HIGHWAYS ADVISORY COMMITTEE SUPPLEMENTARY AGENDA

5 January 2016

Subject Heading:	COLLIER ROW AREA ACCIDENT REDUCTION PROGRAMME – PROPOSED 20MPH ZONE AND SAFETY IMPROVEMENTS (The Outcome of public consultation)
CMT Lead:	Andrew Blake-Herbert
Report Author and contact details:	Velup Siva Senior Engineer 01708 433142 velup.siva@havering.gov.uk
Policy context:	Havering Local Development Framework (2008) Havering Local Implementation Plan 2014/15 – 2016/17 Three Year Delivery Plan (2013)
Financial summary:	The estimated cost of £79,000 for implementation will be met by Transport for London through the 2015/16 Local Implementation Plan allocation for Accident Reduction Programme.

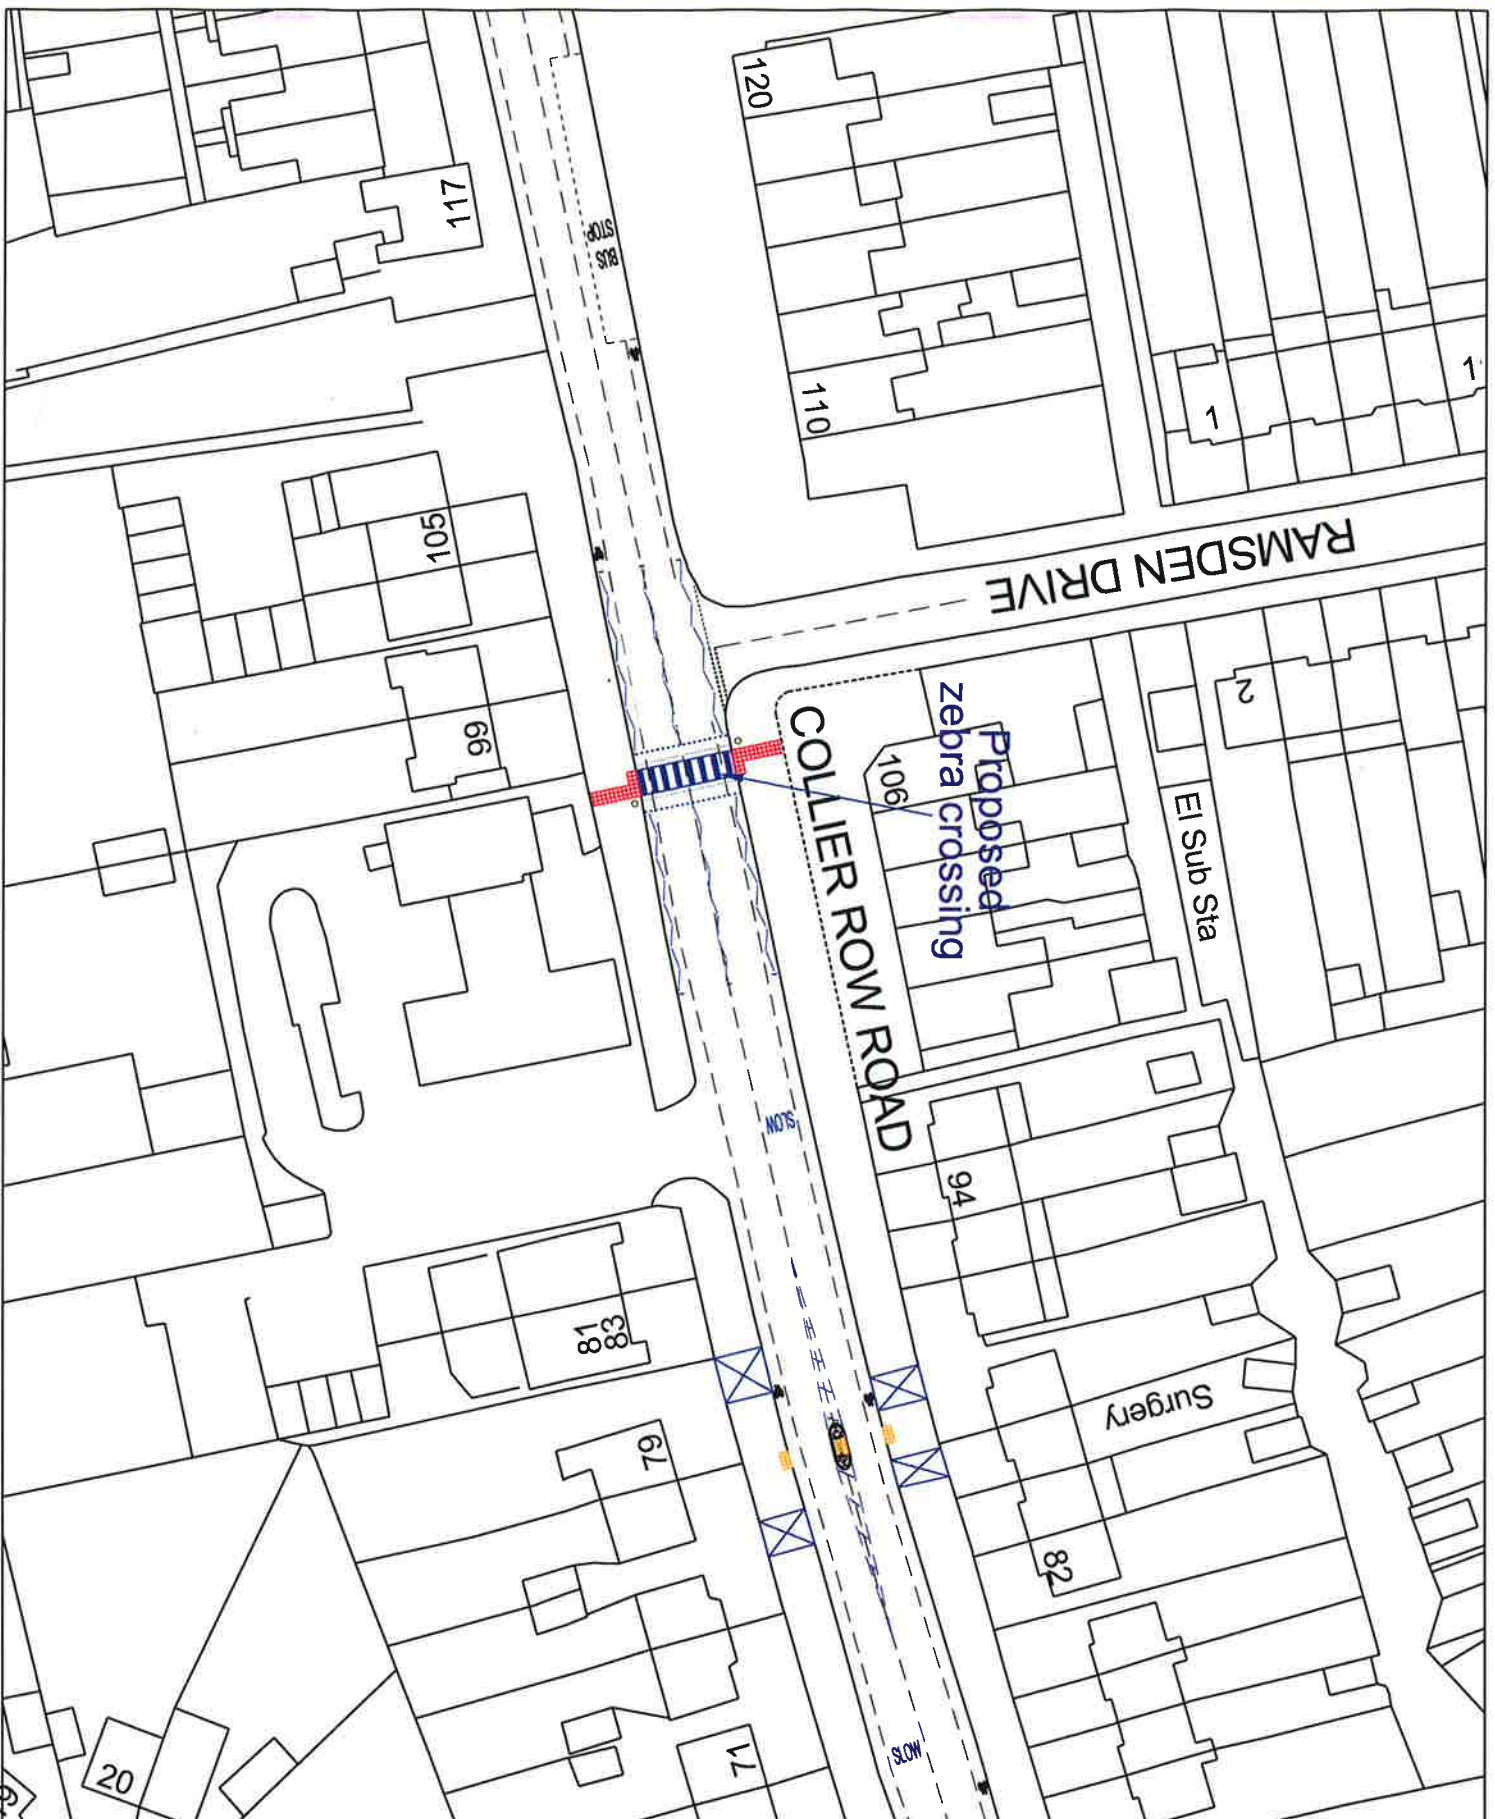
- (a) Collier Row Road by Ramsden Drive (Plan No: QO007/1)
 - Zebra crossing with illuminated posts
 - (b) Collier Row Road between Melville Road and Hamden Hill Roundabout (Plan Nos: QO007/2 and QO007/3)

RESPONSE REF:	COMMENTS	STAFF COMMENTS
QO007/1 (HAC Member)	I am fully in favour of the proposals for the introduction of these new road safety measures in the Collier Row area.	-
QO007/2 (Havering Cyclists)	Another 20mph zone proposal which I support	-
QO007/3 (CTC 'Right to Ride' Network)	The 20mph zone is welcome, provided that it can be enforced. Request to provide sinusoidal profile for speed tables.	The 20mph zone is self-enforcing scheme. Staff considered that the sinusoidal profile is not suitable for this location.
QO007/4 (80 Collier Row Road)	<p>I need to raise a few points in opposition to the proposals</p> <ul style="list-style-type: none"> - I have witnessed vast amount of drivers using their mobile phones and majority of accidents are not speed related - Humps cause vibration and damage to the vehicles - Hitting humps at speed poses a much higher risk of drivers losing control and thus possible more serious accidents. 	Staff considered that the proposal would reduce accidents and would not cause significant problems.

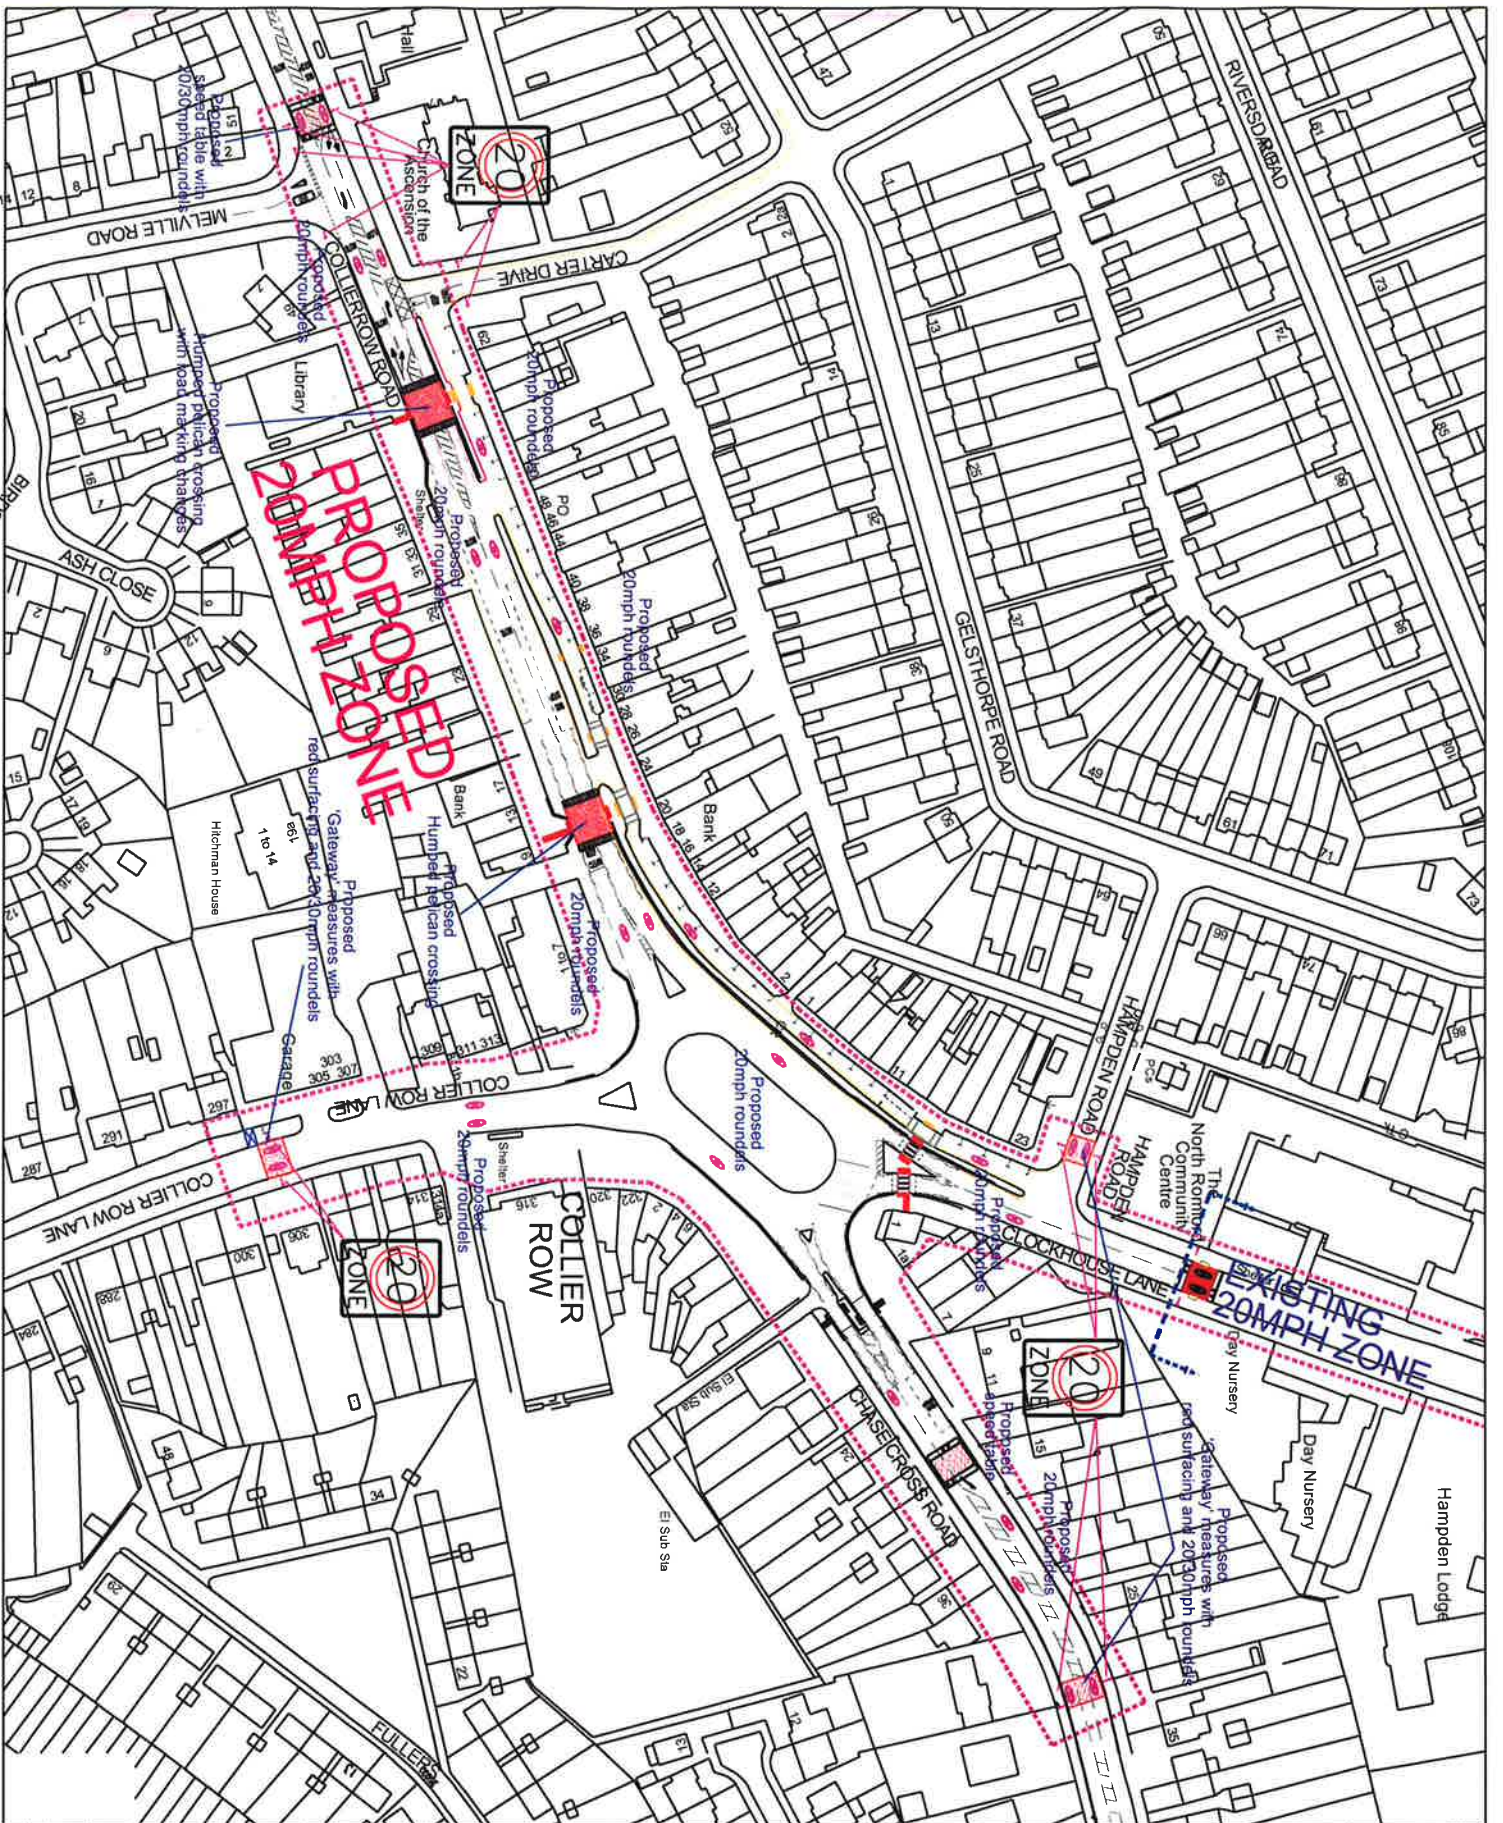
- 20mph zone
 - Speed table with 20/30 mph roundels by Melville Road
 - Raised speed table with minor road marking changes at the existing Carter Drive pelican crossing

- Raised speed table at the existing Hampden Hill Roundabout pelican crossing
 - 20mph roundels at various locations including along service road as shown
